Title: Lake Minnetonka Flats Development

Prepared by: Name: Veronica Sannes, Permitting Technician
Phone: 952-641-4580
vsannes@minnehahacreek.org

Recommendation:

Approval of Minnehaha Creek Watershed District (MCWD) permit application on the following conditions:

75' BUFFER EXHIBIT

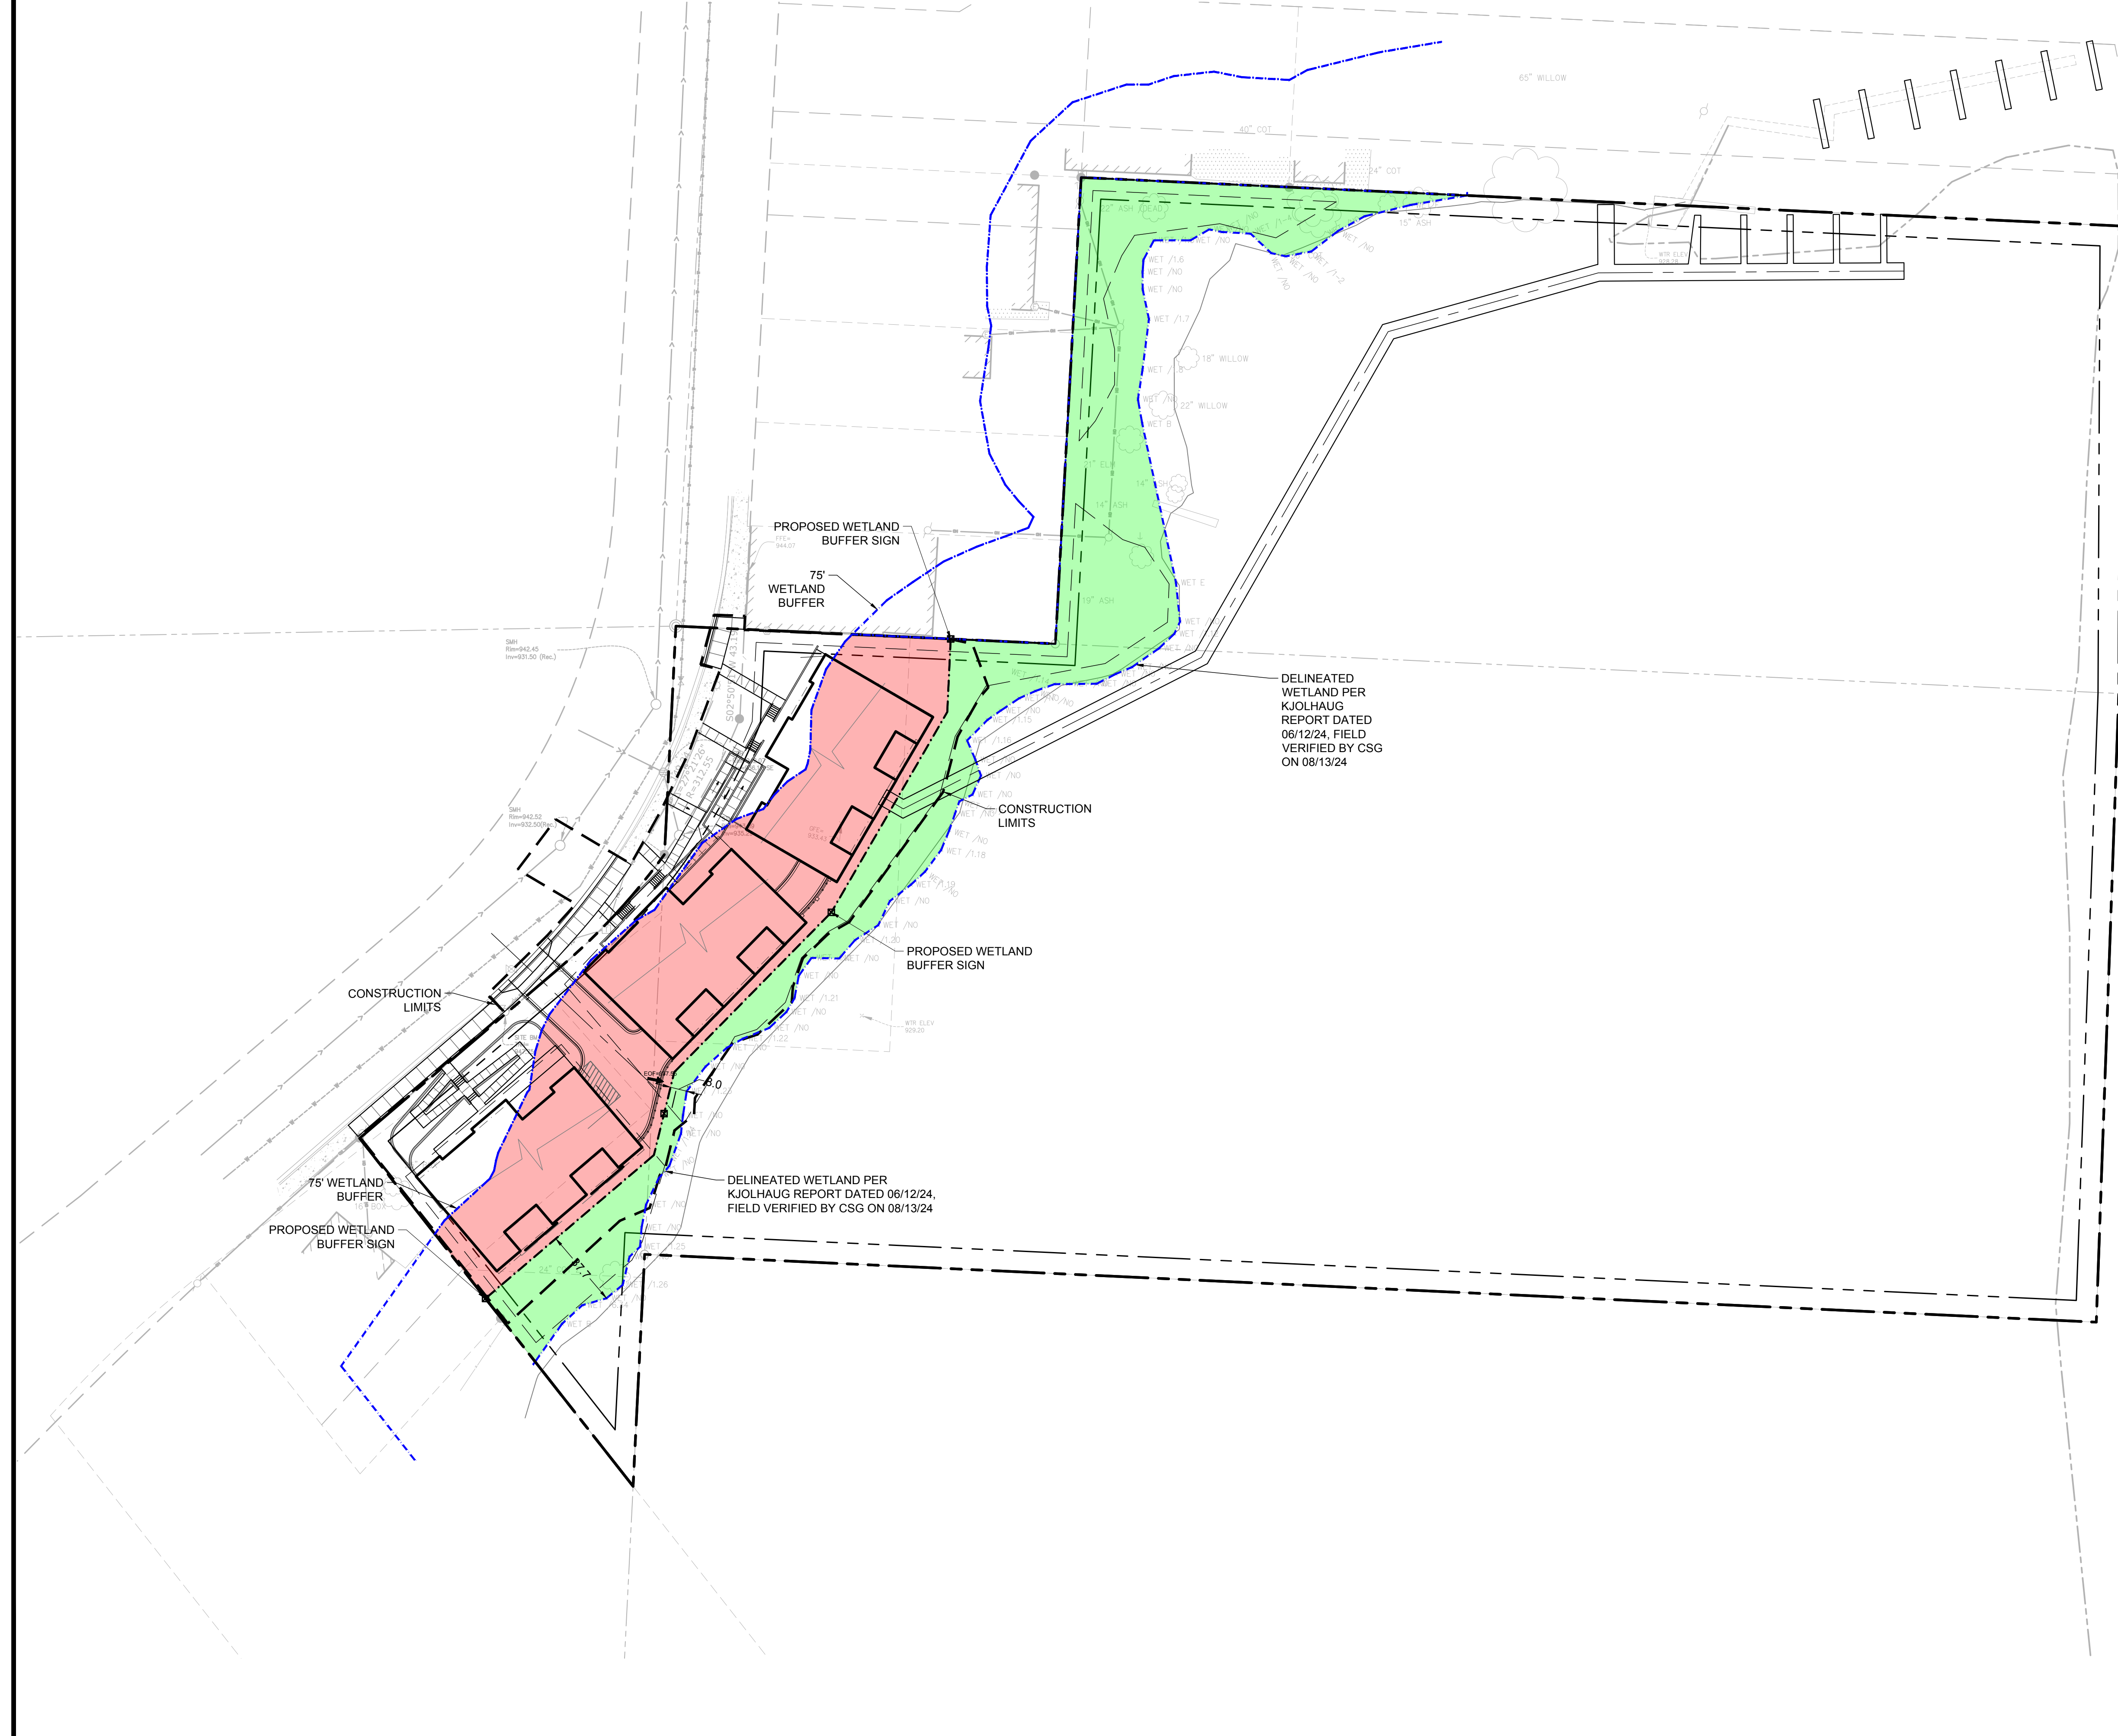
The Applicant instead proposes a buffer that ranges from 8.0 to 37.7 feet and is, on average, 25 feet in width and is approximately 750 feet in length. The Applicant proposes for the proposed buffer to be improved by extending the buffer footprint to the northern area of the parcel, incorporating soil amendments, and implementing an enhanced planting plan. Establishing a 75-foot buffer and full rule compliance would result in 0.74 acres of buffer. The Applicant proposes a reduced buffer with an average width of 25 feet and an area of 0.51 acres.

Section 5(c) states that buffer width at any point may be reduced to no less than 50% of Base Width, provided total buffer area is maintained. The Project does not meet those requirements as 50% of the 75-foot Base Width is 37.5 feet, and the majority of the proposed buffer has a width less than 37.5 feet. The minimum and maximum buffer widths are 8.0 and 37.7 feet, respectively. Section 5(d) states that the District may accept a shortfall in buffer area if the Applicant demonstrates that proposed buffer conditions will provide function and value equal to or greater than that which a buffer or required area would provide. The proposal also has a shortfall in buffer area, which the Applicant proposes to account for by the wetland buffer improvements and additional stormwater treatment.

LANDSCAPE PLAN

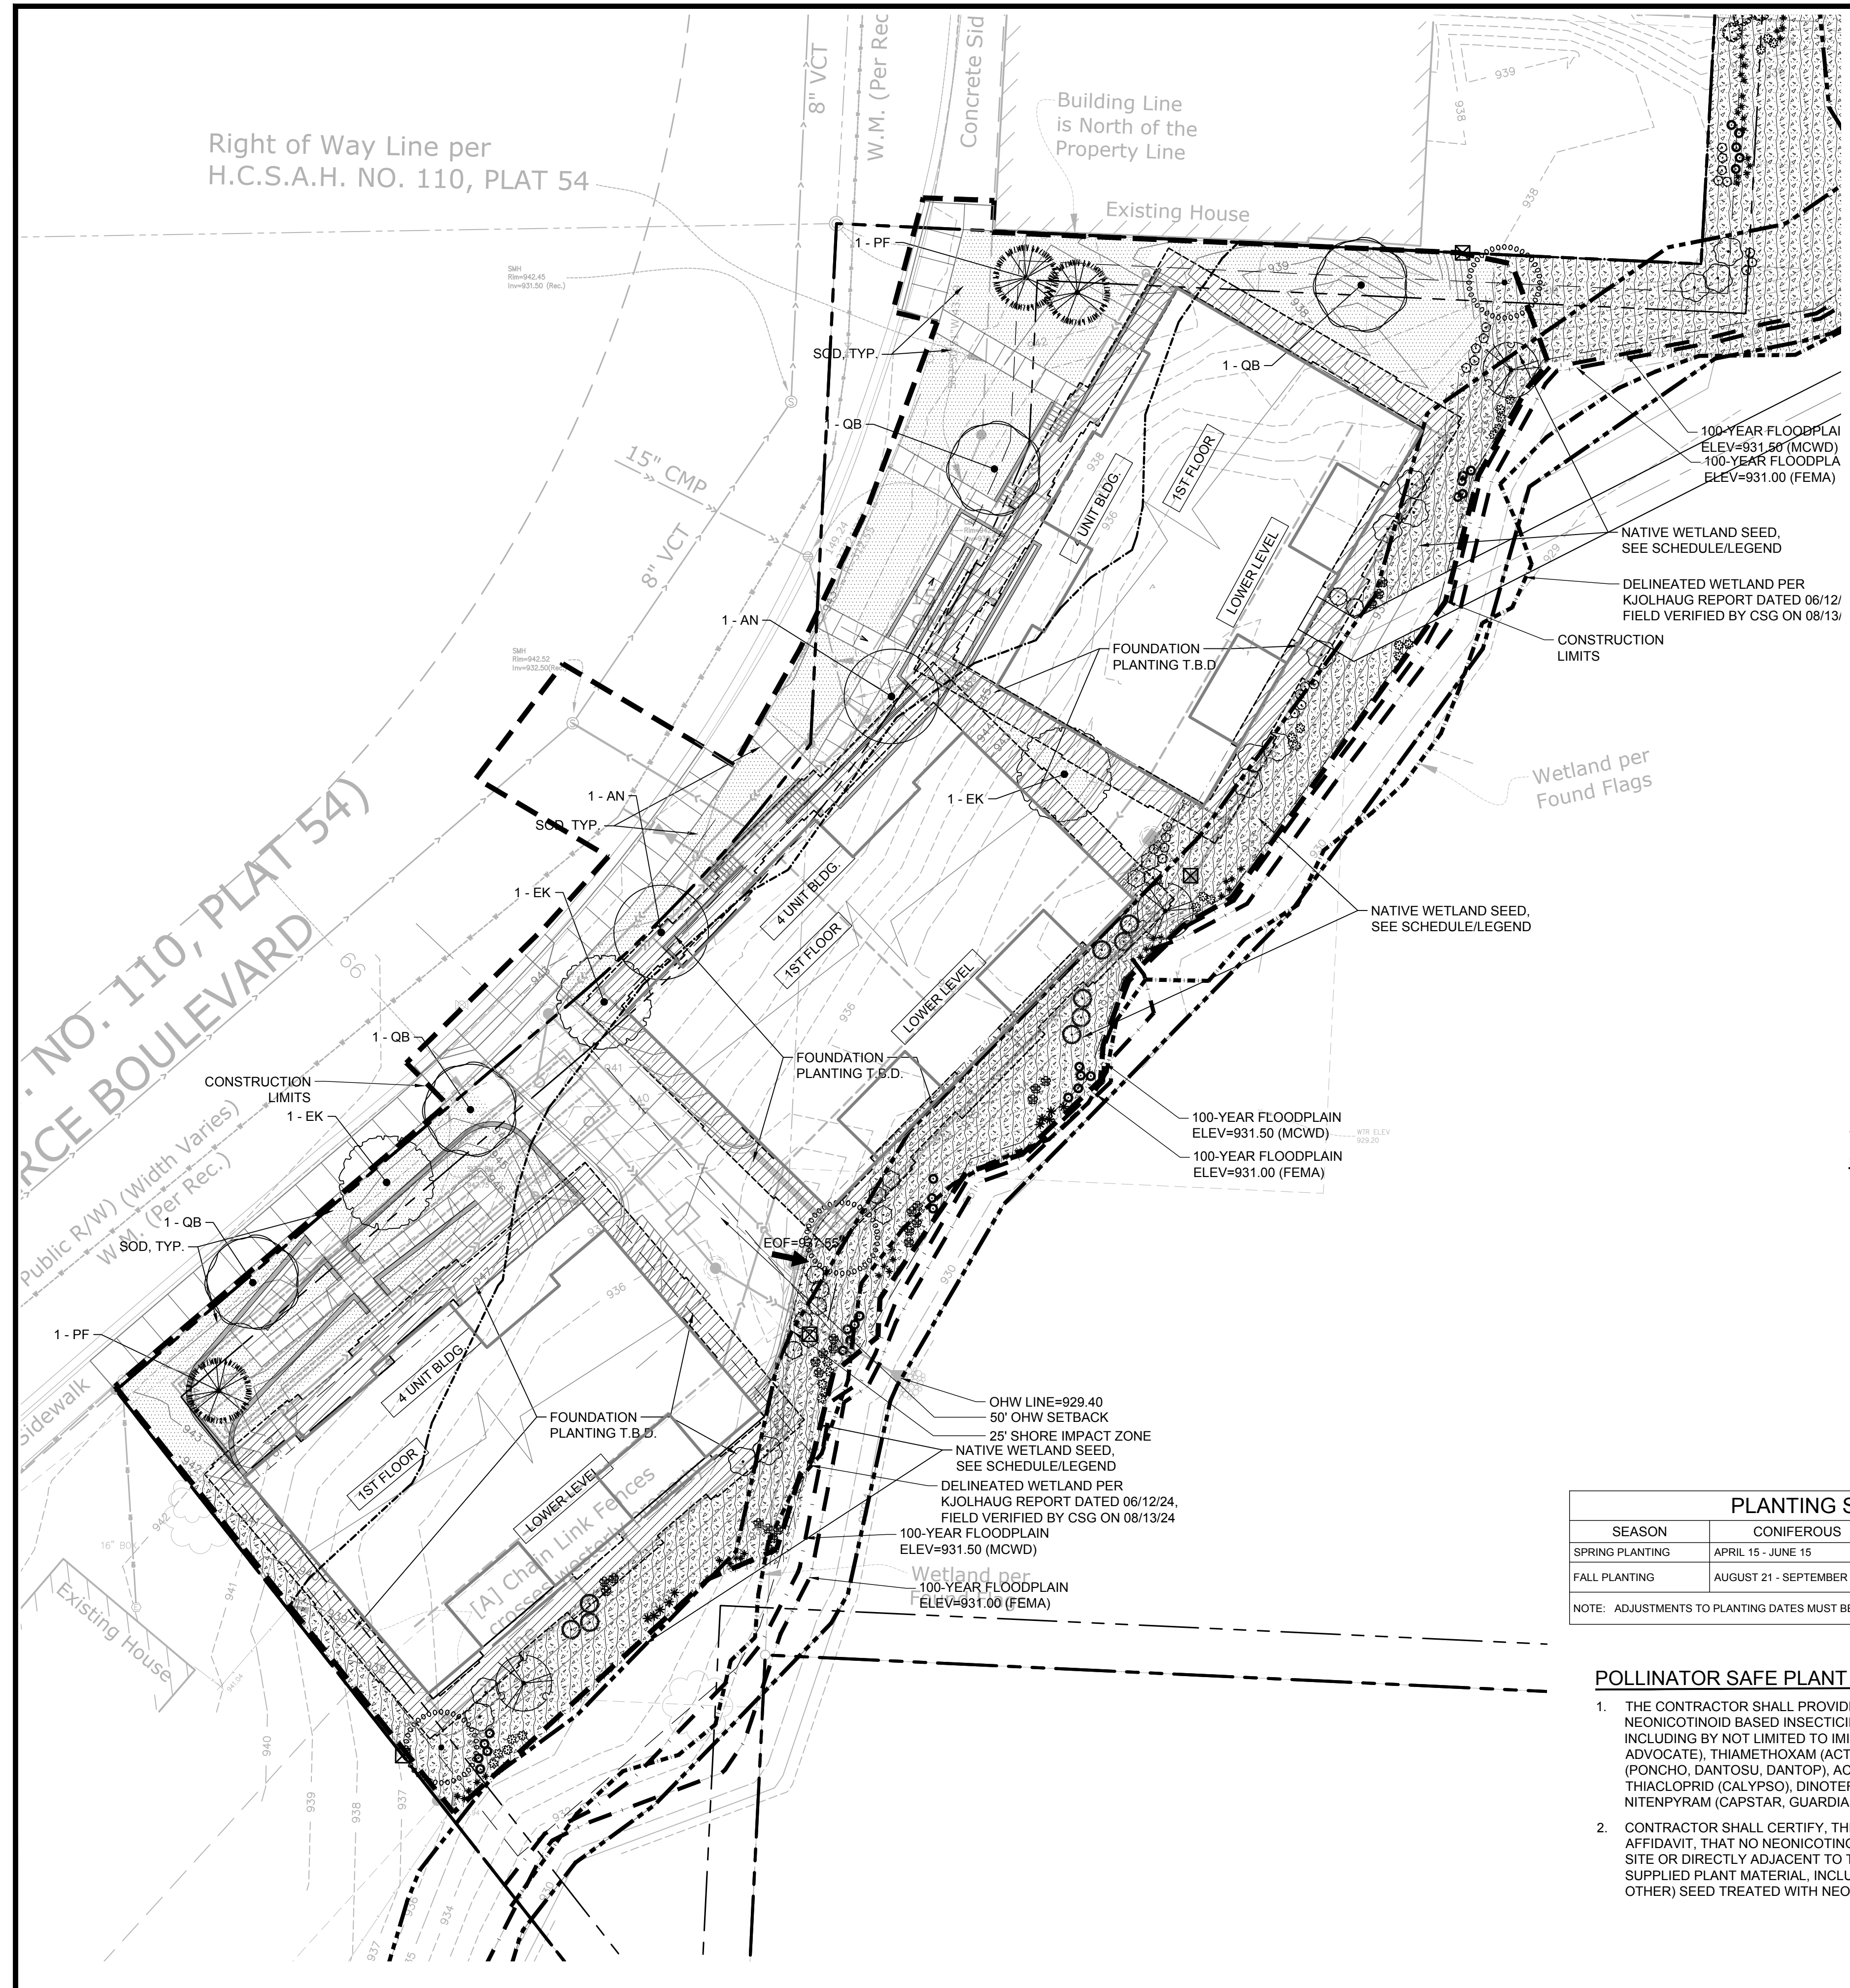
The Applicant proposes to enhance the buffer in three ways: (1) Extend the wetland buffer into the northern areas of the site, where the buffer is not required, (2) Implement soil amendments to the wetland buffer area, and (3) Provide enhanced wetland buffer habitat by planting native trees and shrubs into the wetland buffer area, rather than relying solely on a standard seed mix.

Section 7 of the Wetland Protection Rule requires that wetland buffer planting plans specify the seeding or planting method, but does not require a specific approach. As a result, a standard native seed mix planting plan meets rule requirements. The Applicant has proposed an enhanced planting plan which combines a base native seed mix with 253 larger plugs of native trees, shrubs, and forbs. Incorporating trees and shrubs into a planting plan not only increases biodiversity but also leverages the presence of more mature plants to have earlier habitat and water quality benefits. The Applicant is working with MCWD to develop a suitable maintenance plan for the wetland buffer vegetation, with the finalization of this plan being a condition of permit approval. The proposed plan includes watering the buffer with approximately 1 inch of water per week, when necessary, using an erosion control blanket to prevent erosion, performing bi-monthly weeding, replacing plants annually to ensure full vegetation cover, and conducting annual tree and shrub pruning.

1. Incorporation and conformance of specific buffer soil amendment and planting plan.
2. Continued maintenance in accordance with the planting maintenance plan to ensure proper buffer establishment.
